# TECHNICAL SERVICE INFORMATION BULLETIN

TSIB 25-01 Rev A		May 21, 2025
<b>TO:</b>	All Operators	
<b>TITLE:</b>	TK QS616 HVAC Screw Compressor Clutch Bearing Replacement Interval	
<b>APPLICABILITY:</b>	All New Flyer XD60, XN60 and XDE60 buses equipped with QS616 TK HVAC screw compressors

**Date:** December 13, 2023  
**Subject:** Bus Screw Compressor Clutch Bearing Replacement Interval  
**Location:** e-Tech Library

**New Clutch with Bearing P/N 773261**

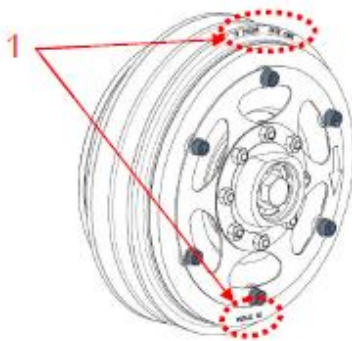
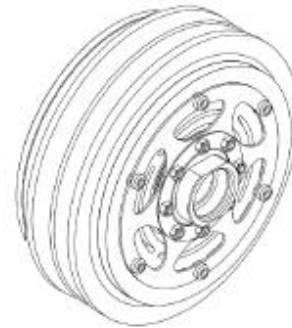
A clutch originally built with the new bearing 773261 can be identified by:

1. The clutch assembly with new bearing 773261 has part numbers etched in the armature plate, pulley, and coil (no disassembly required to view).
2. The new clutch bearing 773261 has "454" etched onto the inner bearing race (disassembly required to view).

**Clutch Bearing Replacement Service Procedure:**

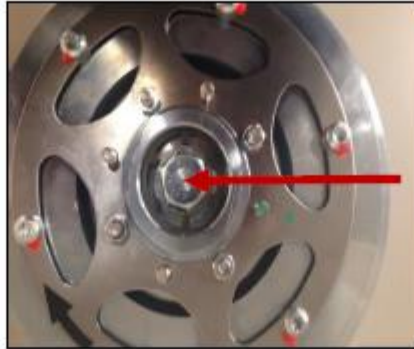
1. Loosen hold-down bolt in hub. Remove hub/armature.

2. Remove clamping sleeve/nut which holds the pulley onto the compressor housing.

3. Remove pulley from the coil.

4. Remove bearing snap ring from the back side of pulley. Press out bearing. Use the inner race lip to press in the new bearing until fully seated. Reinstall the snap ring.

**NOTE:** Use outer edge of bearing race to press new bearing in place.

5. Re-install pulley on coil. Torque the clamping nut to 37 ft-lbs (50 Nm). Pulley should turn free and not contact the coil.

6. Install hub/armature plate hold-down bolt and torque to 63 ft-lbs (85 Nm).

7. Check the air gap after assembly and adjust if needed.

**Specification:** 0.0197 to 0.0315 in. (0.5 to 0.8 mm).
